Product/Process Change Notifications

PCN - 19 016 R1

| Product Name: | SFW, HFW, SFV, SFVL, OPU, VHC and VLL series | | |
| Subject: | Notification of Change with Immediate Effectivity | | |

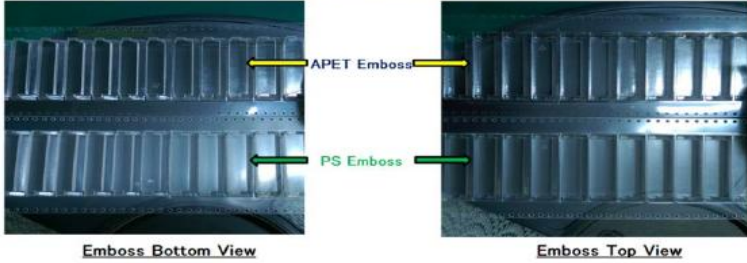
| Change Description: | <p>Change of packaging material of Embossing tape from A-PET to PS Change of packaging Cover tape material from Sumitomo(CSL-Z4110) to AQ-Pack(SXF-404B) Along with the revision of the drawing, to change the notation of the winding dimension on the reel.</p> <p style="text-align: center;"><i>Appearance comparison Between Emboss APET vs PS :-</i></p>  | | |

| Reason for Change: | <p>Embossing tape material is changed for improvement of strength and heat resistance. As a countermeasure against the thermal deformation of the embossed tape during transportation, the material is changed from A-PET to PS with high heat resistance and Cover tape material will be changed to Halogen free material as similar timing. This changes will be made as soon as possible, but since there are many intended products, changes will be made with running changes. It makes compliant with the latest JIS/IEC requirement. The actual specification is already meet JIS/IEC.</p> | | |
